MEMORANDUM

Chapman Avenue Extended (includes existing Maple Avenue) From

CIP No. 5093370

Mandatory Referral No. 06814-DPWT-1

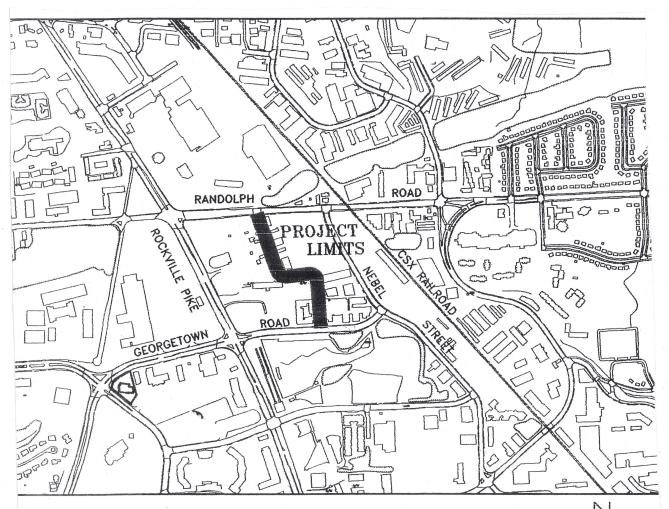
- 2. Reconfigure the eastern 90-degree angle turn/intersection (STA 20+00) to include:
 - a. A driveway treatment for the parking lot that clearly directs through movements on Chapman Avenue.

- b. A level concrete crosswalk across the parking lot entrance to differentiate the pedestrian zone from the automobile zone.
- 3. Designate a signed/shared bikeway on Chapman Avenue and provide "Share the Road" signage to at appropriate intervals along the project length.

The road would improve vehicular circulation in the area and increase vehicular access to properties along Chapman Avenue, however several elements appear to be unfinished in the submitted design. Sheet 4 (STA 20+00, area shown in Attachment 3 of this memo) shows the eastern intersection with offset entrances to existing parking lots. The sidewalk ramps are also offset, which creates an undesirable break in the pedestrian network, in this case directing pedestrians into the middle of the parking lots. Similarly, an automobile exiting either parking lot needs to execute a turning maneuver to avoid driving onto the sidewalk.

The design currently puts pedestrians and vehicles in a potential conflict, rather than clearly delineating the pedestrian zone (crosswalk, sidewalk) from the automobile zone (road, parking lot travelway). Staff recommends reconfiguring the intersection with a driveway treatment for the parking lot so that through movements on Chapman Avenue are clearly identified.
